# UNITED STATES PATENT AND TRADEMARK OFFICE

### Office Action Summary

10/559,611

## **DETAILED ACTION**

**Fig. 1**

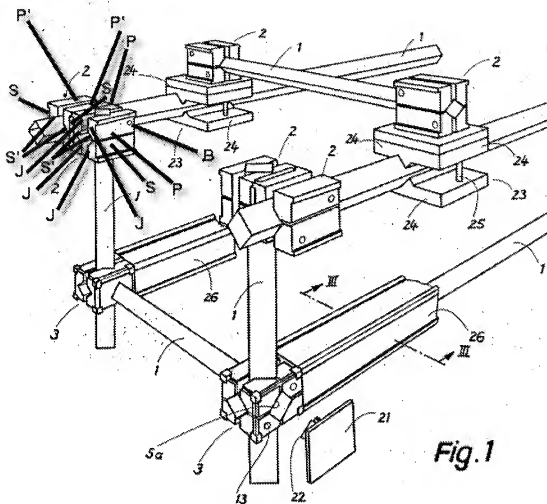
With respect to claim 1, Neff et al. disclose a system (Fig. 1) for detachable joining of at least first and second beams (1) of rectangular cross-section comprising for each said first beam (1) to be joined, a first pair of fixing plates (P) mountable on opposite sides of a said first beam (1) and fixable along said first beam by friction maintained by tightening bolts (B), each one of the fixing plates (P) comprising an inner planar surface (S') adapted to face said first beam (1), and an outer planar surface (S), which in adapted to face away from said first beam (1), for said second beam (1) to be joined, a second pair of fixing plates (P') mountable on opposite sides of said second beam (1) and fixable along said second beam by friction maintained by tightening bolts, each one of the fixing plates (P') comprising an inner planar surface (S') adapted to face said second beam (1), and an outer planar surface (S), which is adapted to face away from said second beam (1), the outer planar surface of said first pair of fixing plates (P) being bearable against the outer planar surface of said second pair of fixing plates (P') when said first and second beams (1) are arranged to be joined in perpendicular or parallel directions, the relative

positions of said first and second pairs of fixing plates (P, P') being fixed by locking elements (constituted by nuts not shown) in recesses in said outer surfaces of the said first and second fixing plates (P, P') said locking elements also anchoring the tightening bolts (B).

Neff fails to disclose the inner planar surfaces of the first and second pair of fixing plates are parallel to the outer planar surfaces of the first and second pair of the fixing plates. There is no criticality is associated with the inner and outer planar surfaces being parallel to one another, since one would know to use this type of system for square, rectangular and/or any other shape beam. Therefore, it would have been an obvious matter of design choice to have the two inner and outer planar surfaces of the fixing plates of Neff being parallel to one another fence since such choice appears to be no more preference which they are known.

With respect to claim 3, Neff et al. disclose (Fig. 1) that the each fixing plate (P, P') comprises projections (J) arranged at each corners of the fixing plate (P, P').

With respect to claim 8, Neff et al. disclose a detachable beam joint system (Fig. 1) comprising a plurality of beams (1) of rectangular cross section, each beam (1) having at least one pair of fixing plates (P) mounted on opposite sides of the respective beam (1) and fixable along the respective beam by friction maintained by tightening bolts (B), each one of the fixing plates (P) comprising an inner surface (S') facing the respective beam (1), and an outer surface

(S) to said inner surface (S') and which faces away from the respective beam (1), the outer surfaces of each pair of fixing plates (P) being bearable against one of the outer surfaces (S) of another pair of fixing plates (P') mounted on opposite sides of another beam (1) when respective beams (1) are arranged to be joined in perpendicular or parallel direction, whereby every surface of every beam (1) is either parallel or orthogonal to every other surface, the relative positions of said pairs of fixing plates (P) being fixed by locking elements (constituted by nuts not shown) in recesses in the outer surfaces of the respective fixing plates, said locking elements also anchoring the tightening bolts (B); and wherein the cross sectional dimensions of all beams (1) are module or a multiple thereof.

With respect to claims 9, 10 and 14, Neff discloses (Fig. 1) that the cross sectional dimensions of all beams (1) are modules; and a beam is comprised of a composite plurality of beams of cross sectional dimension a multiple thereof as much as Applicant's invention is.

With respect to claim 11, Neff discloses (Fig. 1) that each of said first beam (1) and said second beam (1) has an additional pair of fixing plates (P') mountable on opposite sides of said beam (1) and fixable along said beam (1) by friction maintained by tightening bolts (B), each one of the fixing plates (P') comprising an inner surface adapted to face said beam (1).
